MEMORANDUM

SUBJECT: **1200 5th Street NW PUD (Z.C Case No. 19-16: MCF WALP Phase I, LLC)**

The District Department of Transportation Urban Forestry Division (DDOT-UFD) has the following comments for the above referenced project. Please feel free to contact Matt Lehtonen, DDOT Urban Forestry Ward Arborist at matthew.lehtonen@dc.gov and Sharon Dendy, DDOT Urban Forestry Landscape Architect at sharon.dendy@dc.gov should there be any further questions.

Figure 2: Interior trees looking south from N Street NW

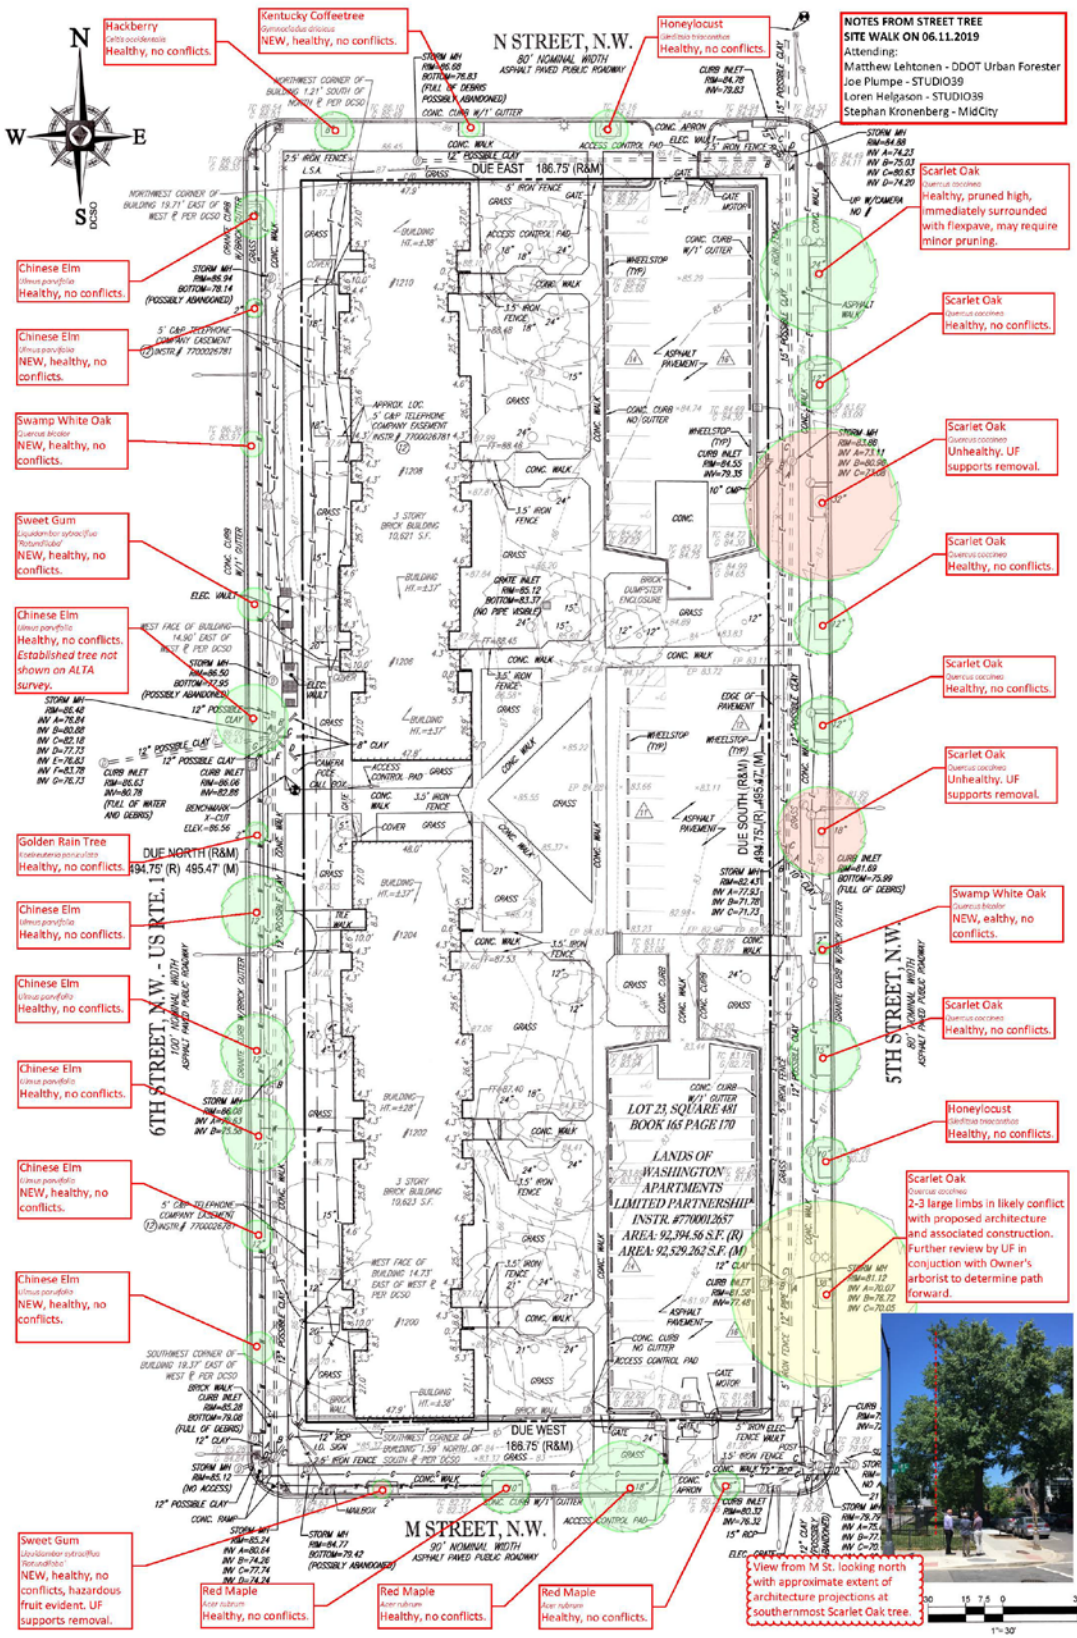
During the June 11, 2019 site visit, the DDOT Ward Arborist noted that almost all the interior trees are healthy/non-hazardous Special trees that will require compensation as per District Law – see Figure 2. Therefore the Developer shall apply for a Special Tree permit so that the DDOT Ward Arborist can enter the site to confirm tree sizes and assess their condition.
